AERONAUTICAL CHARTING FORUM Charting Group Meeting 13-01 – April 24-25, 2013

RECOMMENDATION DOCUMENT

FAA Control # ACF-CG RD <u>13-01-262</u>

Subject: Airport Facility Directory (AFD) Depiction of Traffic Pattern Altitudes

Key to traffic pattern operations

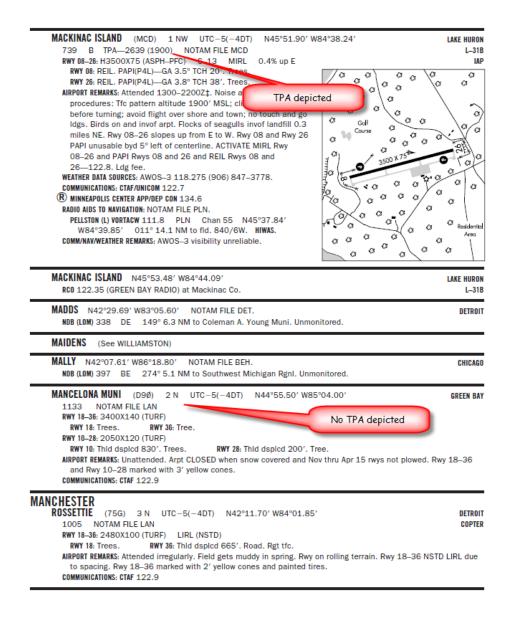
Many years ago, the standard traffic patterns at airports was 800' AGL. The FAA has published in the Aeronautical Information Manual a recommended traffic pattern of 1000' AGL This is only referenced in figure 4-3-2:

Sometimes traffic pattern altitudes appear in the A/FD, sometimes they do not.

- 1. Publish all traffic pattern altitudes or
- 2. Only publish those traffic pattern altitudes that are non-standard, i.e. different than 1000' AGL.
